HARTZELL PROPELLER INC.
SERVICE LETTER
TRANSMITTAL SHEET
HC-SL-30-335
De-ice: Restrainer Strap Installation

This page transmits a revision to Service Letter HC-SL-30-335.

This revision is issued to change the following in the Service Letter:

- Revise Table 1, "Affected Applications"
- Made other language/format changes

B-3852-6-0 Tie Strap Installation on Counterweighted Blades

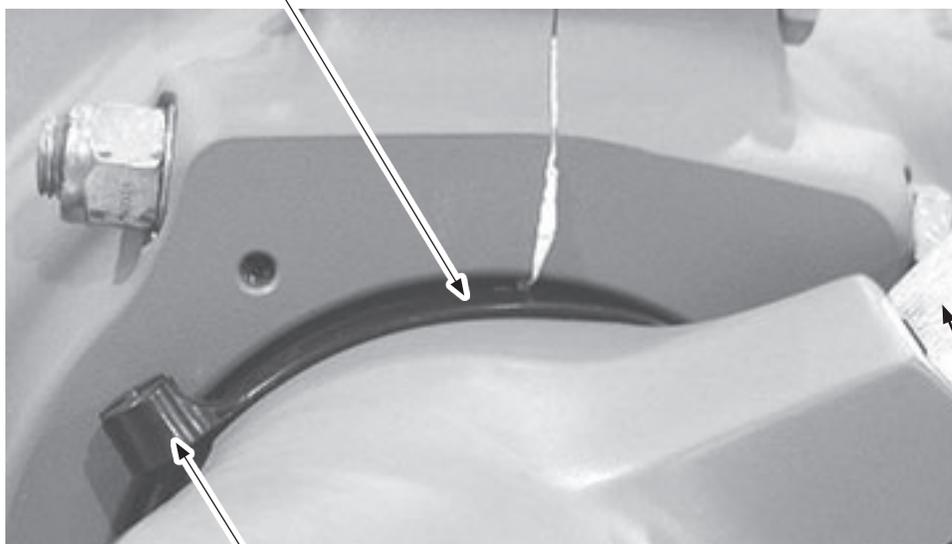
- (b) Install and tighten the B-3852-6-0 tie strap around the bottom of the de-ice boot as shown in Figure 1.
 - (c) All blades in a propeller assembly must be the same configuration.
